# PLANNING DIVISION STAFF REPORT

**Project Address:** 6706-6714 Odana Road

**Application Type:** Demolition Permit, Conditional Use, & Certified Survey Map Referral

**Legistar File ID #** [74052](#), [74053](#) & [74061](#)

Image 1: A portion of the Odana Area Plan’s [Path, Pedestrian, and Bicycle Network Improvements Map](#). (The subject site is highlighted)

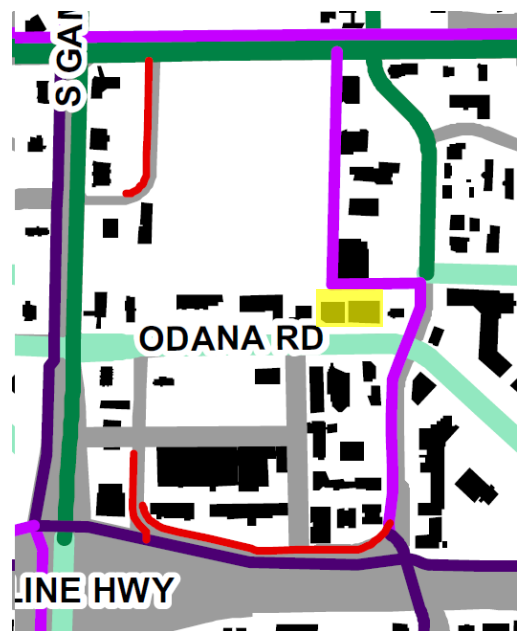
The [Odana Area Plan](#) also recommends a Planned Off-Street Path be constructed along the subject site’s northern property boundary. It will become part of the path which is planned to start at the bend in Grand Canyon Drive adjacent the Beltline, run along Grand Canyon Drive, jog west along the northern edge of the subject parcel, turn north near the northwest corner of the subject parcel, and continue up to the intersection with Mineral Point Road. (The path is shown in the fuchsia-colored line running north-south in the image to the right. The subject parcel is highlighted yellow.) To this end, as easement widths are typically 20’ wide for paths, since the path will straddle the property line, agencies have recommended the

applicant grant a 10-foot-wide easement for the pedestrian and public path along their northern lot line. Note: staff met with the applicant shortly before completion of this staff report to discuss possible forthcoming site plan modifications to accommodate this easement. A condition of approval has been added to this report, noting a revised site plan will be required for full staff approval to accommodate this recommended easement.

1. The applicant shall submit revised plans accommodating the 10-foot property line along the northern property line. These shall be reviewed and approved by City Agencies prior to final signoff.
